## REVISED RESPONSE TO REQUEST FOR ADDITIONAL INFORMATION

### APR1400 Design Certification

RAI No.: 407-8447  
SRP Section: 19.03 – Beyond Design Basis External Event  
Application Section: 19.03  
Date of RAI Issue: 02/17/2016

### **Question No. 19.03-26**

**Figure 1 Locations for SFP FLEX pump connection**

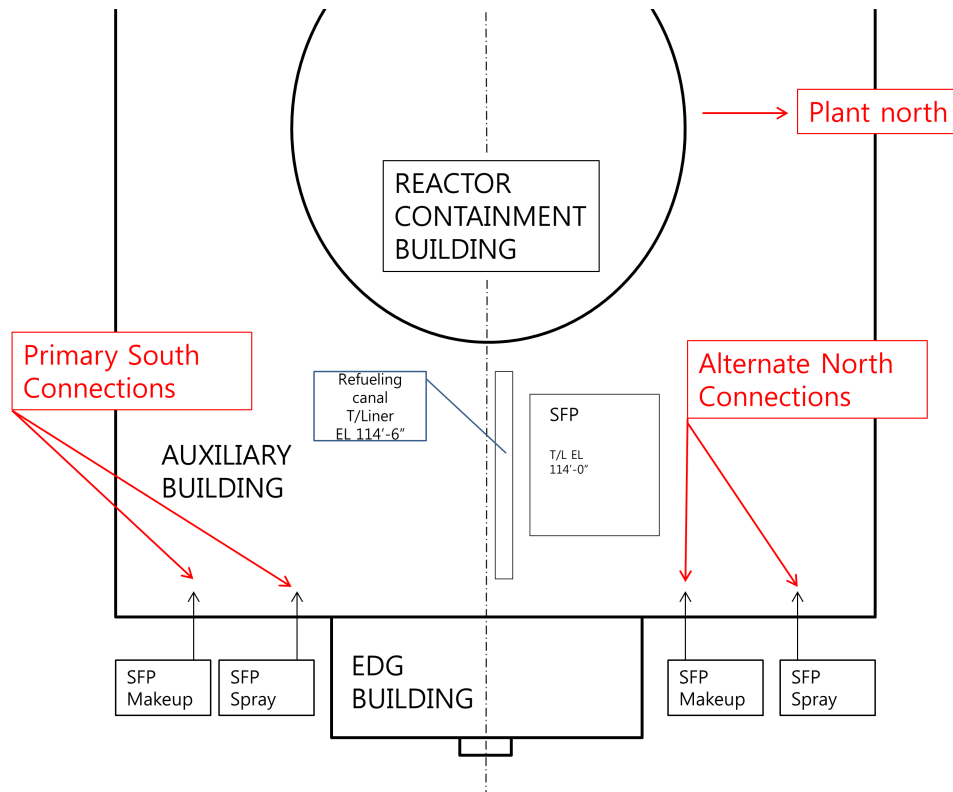
The staff reviewed the information in APR1400-E-P-NR-14005-P, "Evaluations and Design Enhancements to Incorporate Lessons Learned from Fukushima Dai-Ichi Nuclear Accident," Section 5.1.2.4.1.2, comparing it with the NEI guidance. It is not clear whether the connections being used in the proposed mitigation strategies for SFP cooling are consistent with the

guidance that the location of the connection points should provide reasonable assurance of at least one connection being available for all applicable external hazards.

The applicant is requested to clarify how the APR1400 design for connections to the FLEX equipment is consistent with the NEI guidance.

The APR1400 mitigation strategy for SFP cooling is schematically illustrated in Figures 6-2 and 6-3, and the approximate locations for makeup water connections are indicated in Figure 6-4. The APR1400 design provides two locations for SFP makeup water connections: a set of two primary connections (one for makeup and one for spray) is mounted on the outside wall of the Auxiliary Building (AB), adjacent to the south side of the Emergency Diesel Generator (EDG) building; and the alternate set of identical connections (one for makeup and one for spray) is mounted on the outside wall of AB, adjacent to the north side of the EDG building. Please refer to Figure 1 below for illustration.

Since the external hazards (e.g., seismic events, floods, high winds, and associated missiles) are dependent on the site-specific characteristics, the protection design for applicable hazards should be the COL applicant's responsibility. Therefore, new COL item (COL19.3(16)) for the protection of the connections for FLEX strategies from external hazards will be added to DCD Tier 2 Subsection 19.3.2.3.4 and Technical Report APR1400-E-P-NR-14005-P/NP Section 6.2.11, respectively, as indicated in the attachment. In addition, a list of connections for the FLEX strategies (Table 6-5) will be added to Technical Report APR1400-E-P-NR-14005-P/NP as also indicated in the Attachment.
